ATCB comment Answer:

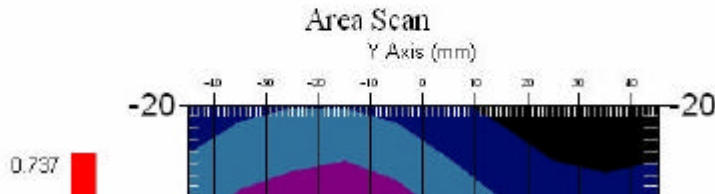
5.) Please outline the positioning of the EUT on the SAR report plots (Appendix B).

ANS: Please refer the EUT position in appendix B of SAR report,

also you can find the position on page 22 of SAR report <06LR032SAR-F>
